## **MEMORANDUM**

**TO:** District of Columbia Zoning Commission  
**FROM:** *JL for* Jennifer Steingasser, Deputy Director, Development Review and Historic Preservation  
Stephen Cochran, Project Manager  
**DATE:** June 26, 2020  
**SUBJECT:** Public Hearing Report for Zoning Commission Case No. 19-19, Consolidated Planned Unit Development, 3301 23<sup>rd</sup> Street, SE Square (5994, Lots 3 – 5)

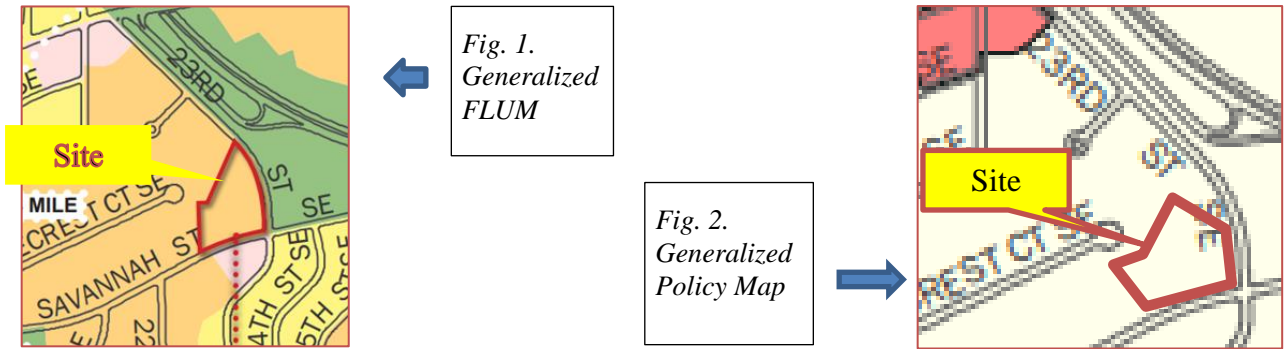
The façade would include a variety of materials, including brick, cementitious siding, aluminum, and CMU veneer. Although there would be vinyl siding on the back of the building, it has been eliminated from the south and east facades since setdown. Sections of the top story have been darkened. More detail has been given to the brickwork. While there would be 27 “Juliet” balconies on the street-facing facades, there would be no occupiable balconies or decks. Since setdown the applicant has added a 2,145 foot community garden in the back of the building, accessed from a redesigned ground floor amenity space (Exhibit 14A4, Sheet 3-3). The residents would also have access to the north-adjacent park and recreation facilities developed by W.C. Smith and depicted on Sheet 2-2 of Exhibit 11A2.
